TOWNSHIP OF RIDEAU LAKES
Planning Advisory and Committee of Adjustment
AGENDA

Wednesday, July 9, 2025, 1:00 p.m.

REPORT TO THE COMMITTEE OF ADJUSTMENT & PLANNING ADVISORY COMMITTEE	
Date of Report: June 26, 2025	Date of Meeting: July 9, 2025
Subject of Report: Section 45 Application A-10-2025 & Site Plan Control Application SP-13-2025 MILLS	
Recommendation: Staff recommend that the Section 45 application A-10-2025 be approved as submitted with the conditions outlined in Section 8 of this report.	
Decision: Site Plan application SP-13-2025 is approved as submitted with the conditions outlined in Section 9 of this report.	
Report Prepared By:	 <hr/> Foster Elliott, Associate Planner
Departmental Approval:	 <hr/> Tom Fehr, Manager of Development Services
Chief Administrative Officer (CAO) Approval:	 <hr/> Shellee Fournier, CAO

REPORT TO THE COMMITTEE OF ADJUSTMENT & PLANNING ADVISORY COMMITTEE	
Date of Report: June 26, 2025	Date of Meeting: July 9, 2025
Subject of Report: Section 45 Application A-19-2025 & Site Plan Control Application SP-26-2025 CONSTANTINE and LUMBERS	
Recommendation: Staff recommend that the Section 45 application A-19-2025 be approved as submitted with the cond

Figure 5 (below) – Site Plan Drawing

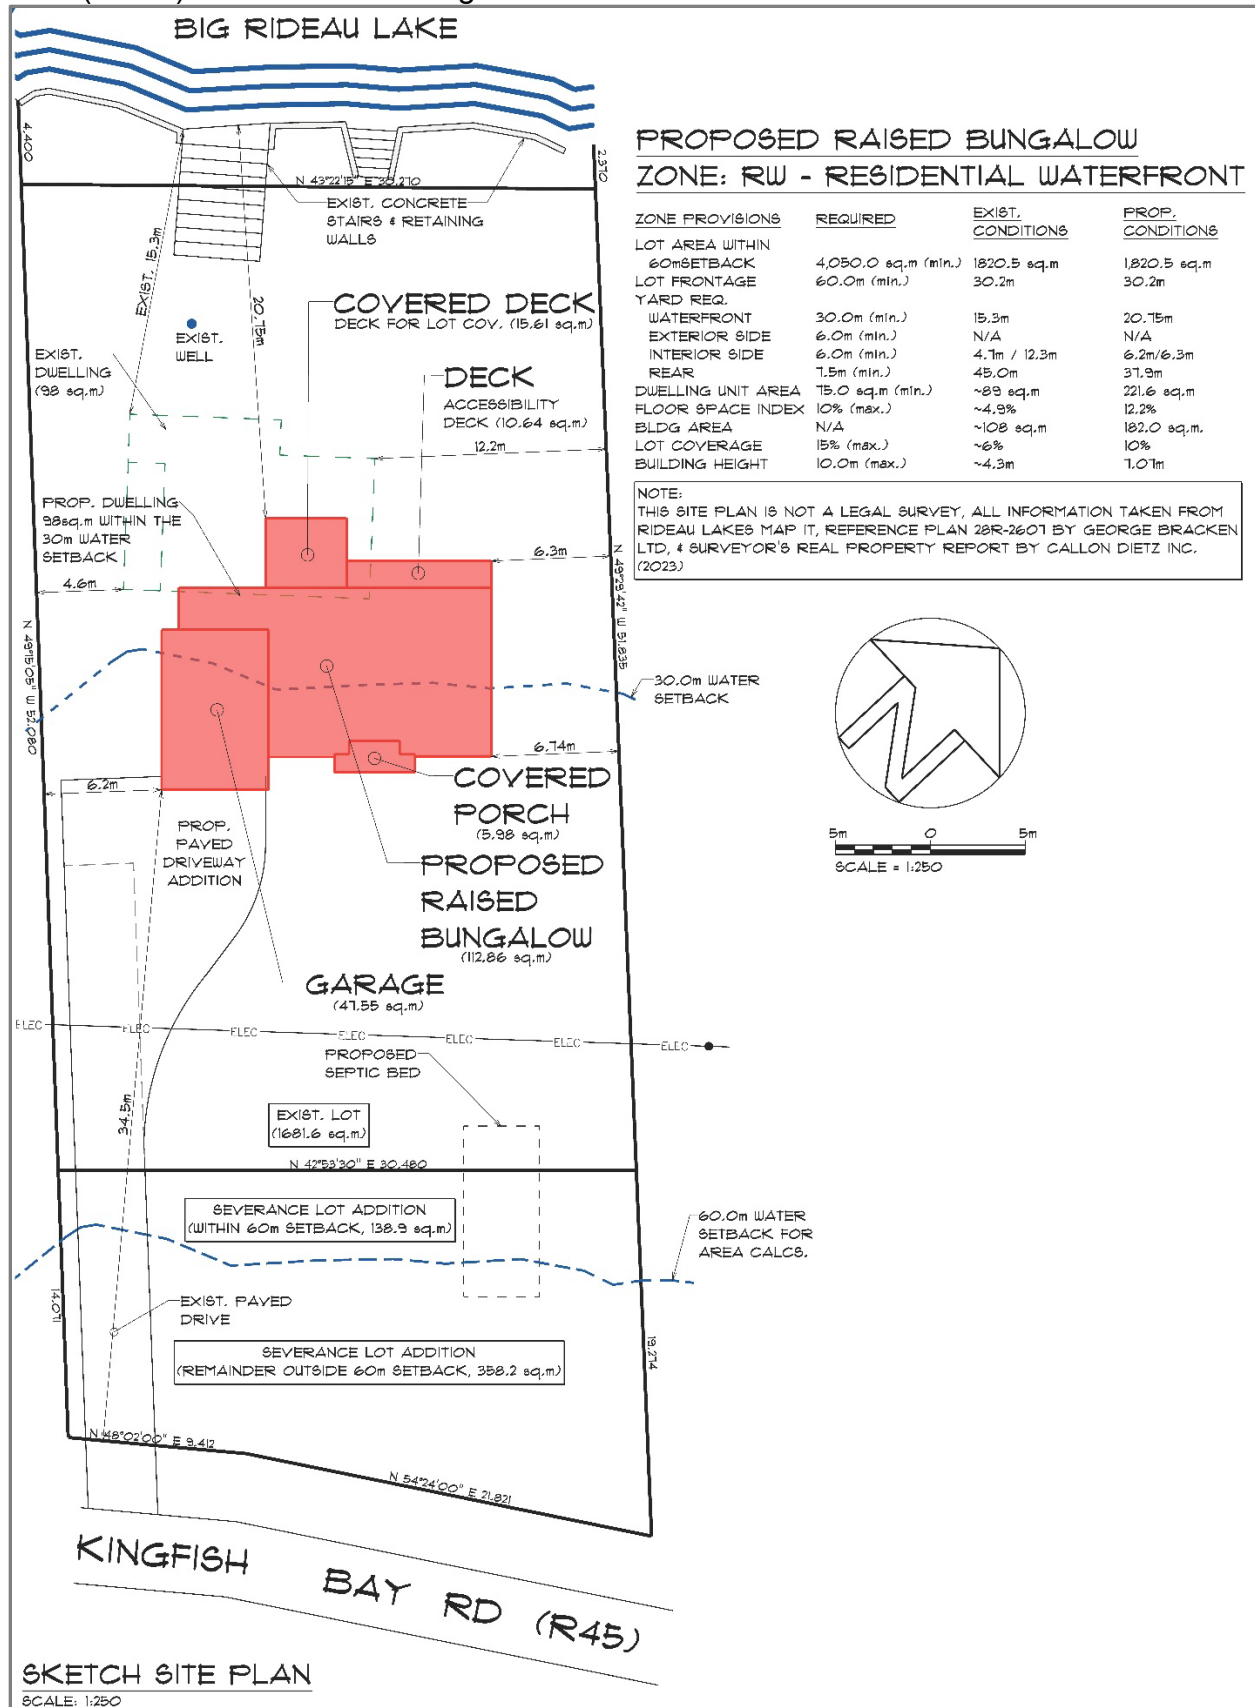
Comment: The proposed enlargement to the non-conforming dwelling is located no closer to the water, but actually relocated further from the water. Considering the balance of the ability to reconstruct the dwelling in the same location, and the willingness of the application to relocate the dwelling further back, the water setback has been maximized considering the existing pattern of development on the lot.

Comment: The property has an existing septic system which is proposed to be removed, and a new septic system installed. The proposed septic system on the site plan drawing is located at the rear of the property well exceeding the minimum 30m water setback. Therefore, the development does not hinder the ability for the septic system to be complying with the minimum 30m water setback.

- 4) That the owners adhere to the submitted Shoreline Buffer Planting Plan. The owners shall encourage the development of a shoreline naturalization buffer (no disturbance area) extending up to 15m back from the high water mark;

Figure 5 (below) – Site Plan Drawing

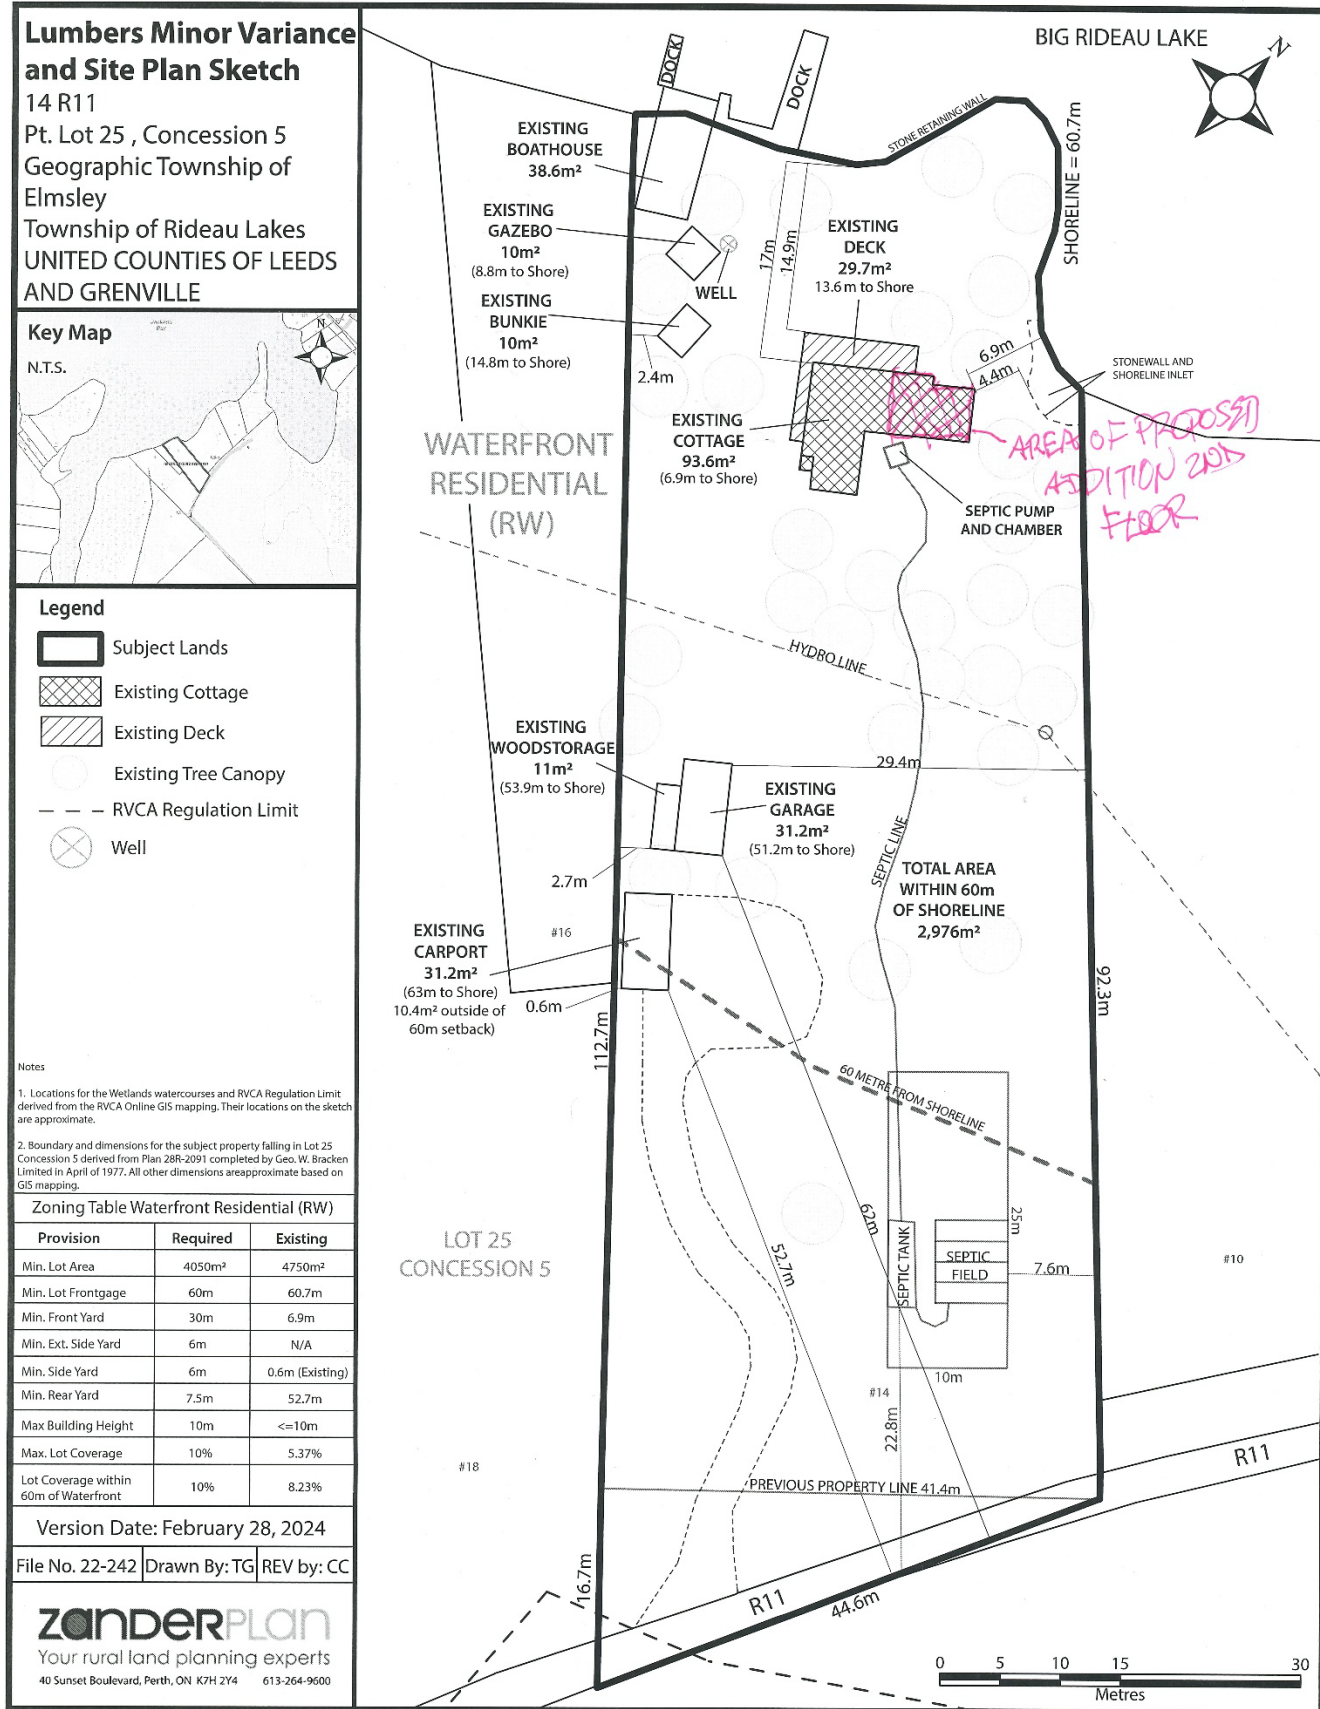
Comment: The proposed enlargement of the dwelling is fully within the existing footprint of the dwelling which maintains the existing setbacks to the water. The increases are to install a partial second storey which includes an increase to the height of the building. As no development is proposed that goes closer to the water, this proposal does not further aggravate the extent of non-conformity of the dwelling.

Comment: The property has an existing septic system which is located outside of the 30m water setback based on the submitted site plan drawing. The enlargement does not occupy more of the property than the previous development, so therefore does not hinder the ability for the septic system to be located in conformance with the minimum 30m water setback.

- 4) That the owners adhere to the submitted Shoreline Buffer Planting Plan. The owners shall encourage the development of a shoreline naturalization buffer (no disturbance area) extending up to 15m back from the high water mark;

Figure 5 – Site Plan Drawing

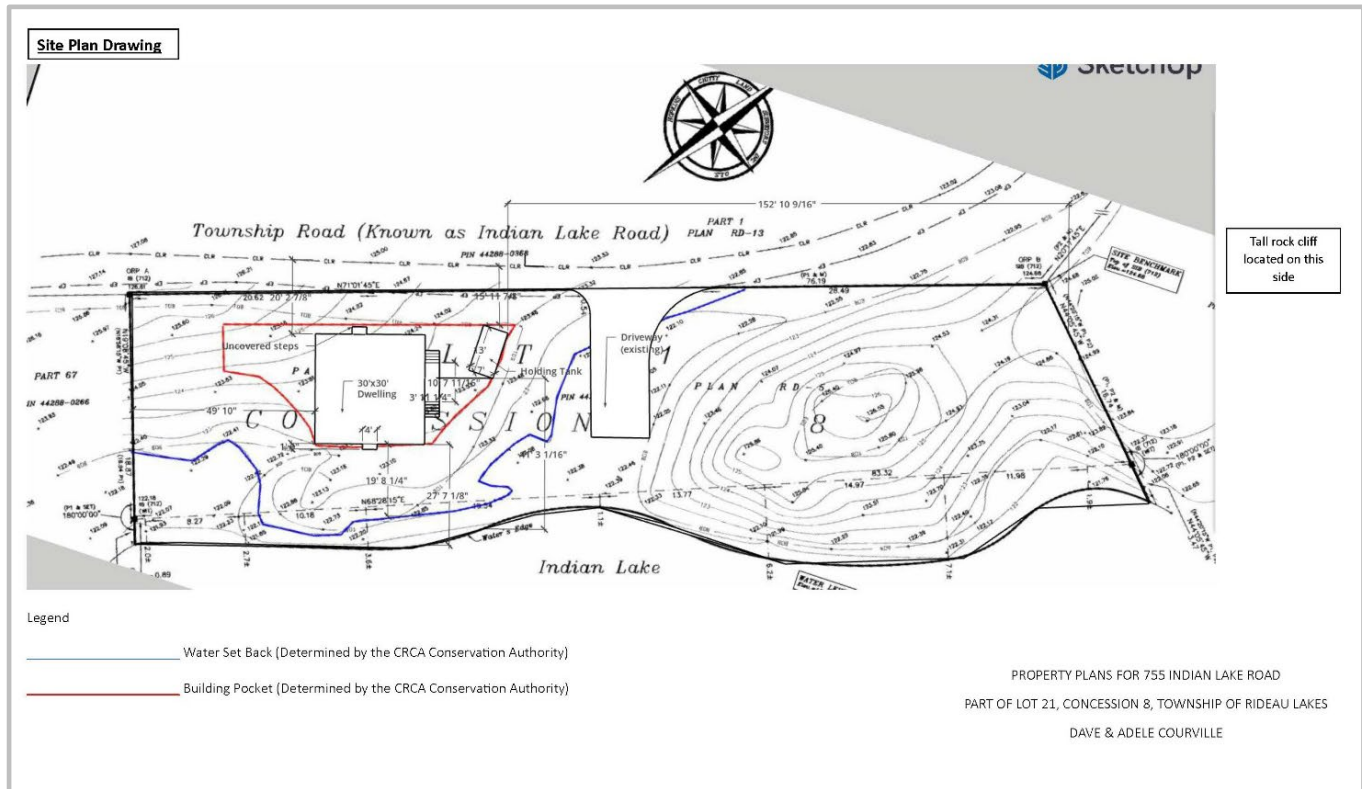
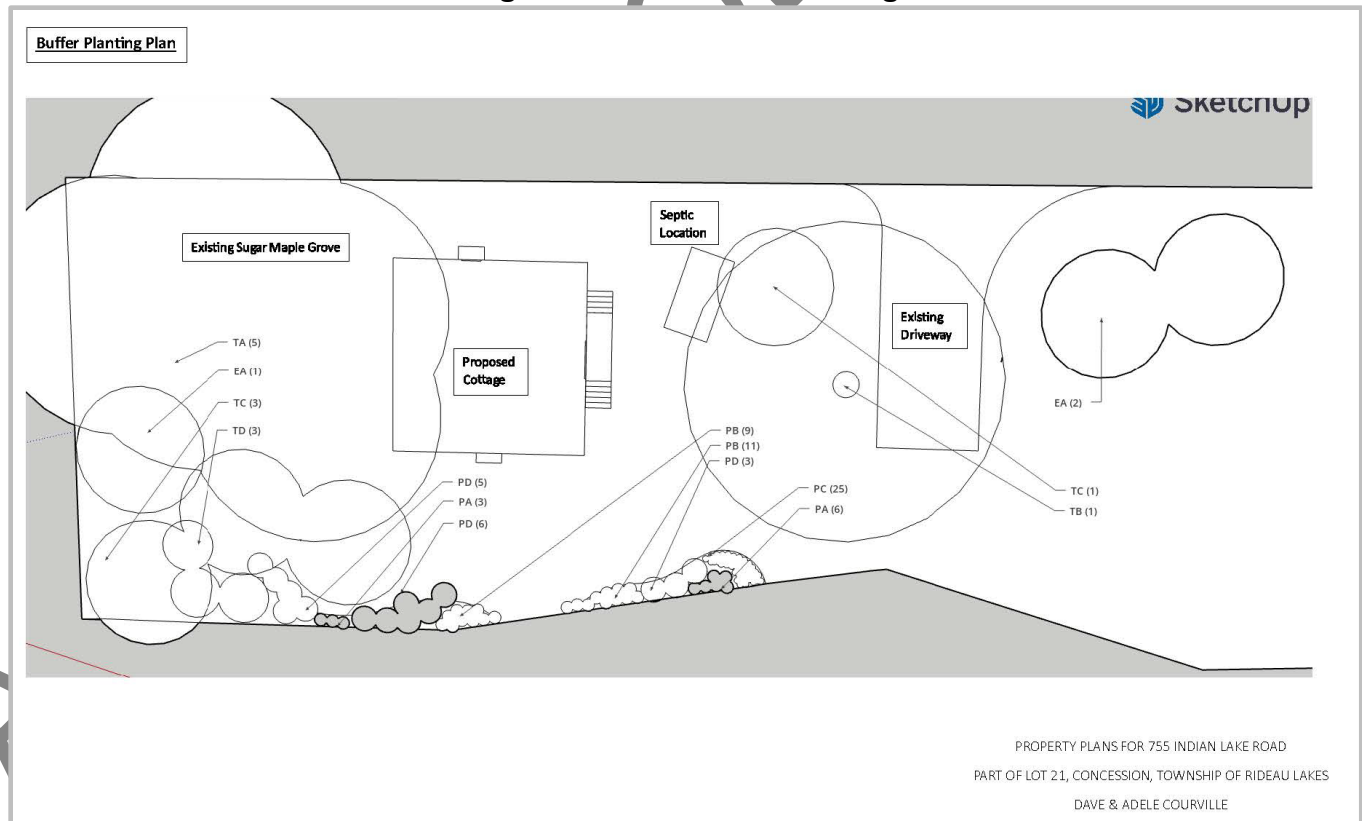
Overall, staff are recommending deferral to provide for more time to examine the size and layout of the dwelling to assist with meeting Section 2.4.5C and 2.6 of the OP, as well as more time to update and peer review the EIS to ensure the application meets sections 2.20 and 3.4 of the OP, and it is recommended that an updated shoreline buffer planting plan be submitted that shows a more robust natural vegetative state on the remainder of the property to meet the intent of sections 2.2 and 2.6 of the OP, and lastly to allow for more time for formal comments to be received from the CRCA and Parks Canada to meet section 2.17 and 2.18 of the OP.

Other comments were received on the proposed septic system, and indicated that in the event of a failure of the system, all sewage will dispose of directly into the lake. By nature a holding tank does not discharge at all into the environment. As such, a holding tank is therefore pumped out frequently, and any of these pump outs can be checkpoints for the owners or sewage hauler to ensure the system is working properly. Although concerns have regard to a potential failure of the system, all septic systems that are installed are to be regularly inspected and maintained by the property owner. The Township would not be in a position to decline an application due to a hypothetical failure of a new sewage system, as any sewage system can fail for any number of reasons.
